TECHNICAL BULLETIN

Description: XTX Ratchet Feature

Product Effected: XTX 200 Tungsten, XTX 200, XTX 100, XTX 50

Serial # Effected: 9050001 and Onward

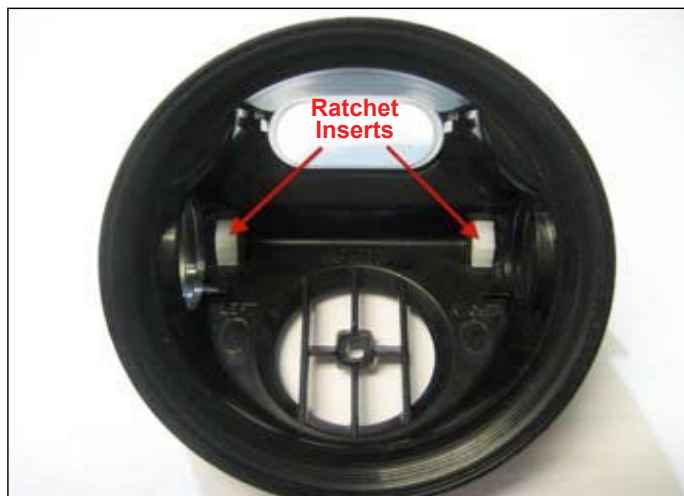
We write to inform you of a recent decision to remove the ratchet feature from all XTX regulator venturi levers. This decision has been made due to consumer preference and to aid the manufacturing process. This will not affect the performance of the XTX regulator.

This has been achieved by removing the two ratchet inserts, in the 2nd stage case.

Regulator models which are affected are the XTX200 Tungsten, XTX200, XTX100 and the XTX50. The serial numbers of the new non-ratchet models are 9050001 and onwards. All regulators prior to this serial number will have the ratchet feature assembled as normal. There is no need to remove any ratchet inserts from in service regulators, as there are no technical issues. All XTX regulator maintenance manuals will remain unchanged showing the picture of the ratchet inserts fitted.
